**BOUNTIFUL CITY
PLANNING COMMISSION AGENDA
TUESDAY, APRIL 7, 2026
6:30 P.M.**

Planning Commission Staff Report

Subject: Zone Map Amendment from R-4 to MXD-R
and Orchard Flats Development Plan at 2523
South 100 West

Figure 3. Time-of-day parking requirements, Hales Engineering Parking Study, Page 4

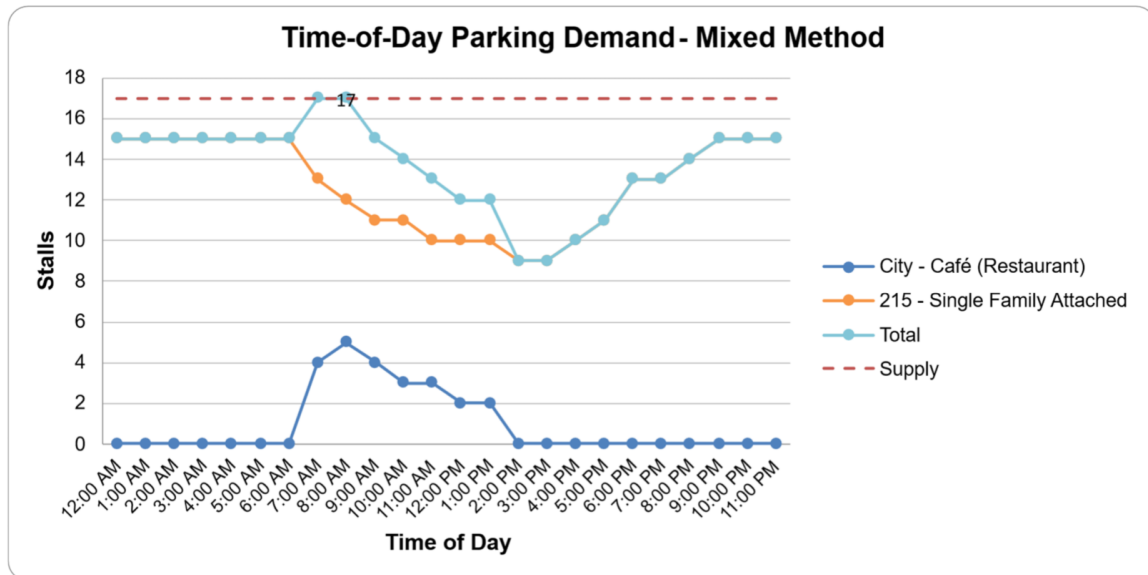
The study provided indicates there is enough parking to offset parking demands for both a small restaurant/café and six (6) multi-family residential townhomes, as shown in both Figure 3 and Table 4; however, the analysis is based on preliminary or assumed commercial use characteristics and may not fully reflect the parking demand of the proposed café/restaurant use. Based on staff’s review, parking demand could be higher depending on the final use and intensity, and final verification of parking adequacy is subject to review under Section 14-10-108(5).

Exhibit A:

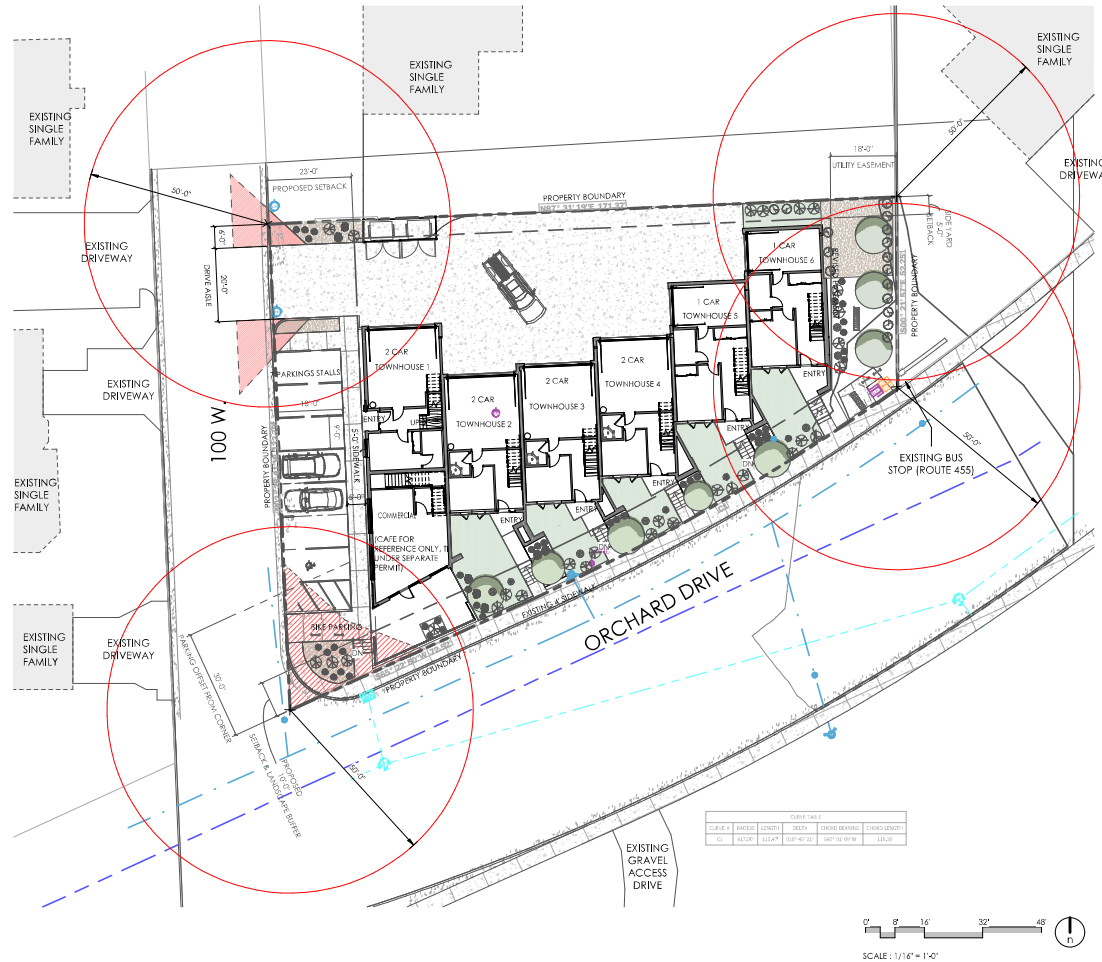
- Transition from Orchard Dr. to new parking.
 - Intent is to closely match existing grades at this location. Further review of existing grades shows roughly 2'-6" from existing to new top of stair/sidewalk. We propose a revised site wall at the stair to follow the slope of the stair and improve sightlines at the corner. We also propose eliminating the street tree previously shown at the commercial plaza to ensure that the tree crown doesn't conflict with sightline and pedestrians at the sidewalk level. See MXD Preliminary Site Plan – Existing & Proposed Grading & Setbacks, and MXP Concept Color Massing Elevations, and attached exhibit A.
